SERVICE BULLETIN

| REFERENCE | ENGINE |

7M-G(T)E ECU / COLD START INJECTOR TIME SWITCH MODIFICATION

This bulletin contains additional information to TSB Volume 10, Engine #010 previously issued 09-01-89.

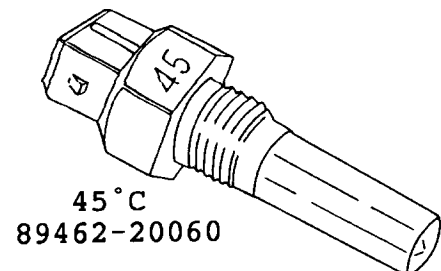
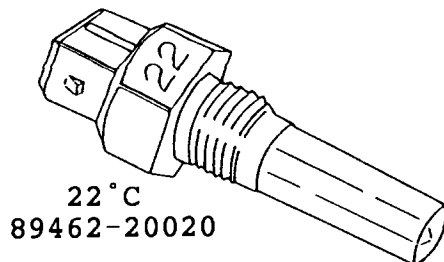
The modified cold start thermal time switch listed in Engine TSB #010 is still available for 1986-1989 Supras and Cressidas equipped with 7M series engines to improve **startability only**.

CAUTION: The new TCCS ECU **should not be used** with the new 45° C Thermal Time Switch. This ECU has improved cold start injector control logic and is designed to work with the original 22° C time switch only.

The illustration below shows how to identify the temperature range of a cold start injector time switch.

| PART NAME | PREVIOUS P/N | NEW PART NO. | MODEL APPLICATION |
|---------------------------|------------------------|-----------------------|--|
| Thermal Time Switch | 89462 -20020 (22°C) | 89462-20060 (45°C) | '89 7M-GE and 7M-GTE Supra and Cressida |
| Thermal Time Switch | 89462 -40010 (22°C) | 89462-20050 (45°C) | '86-'88 7M-GE and 7M-GTE Supra |
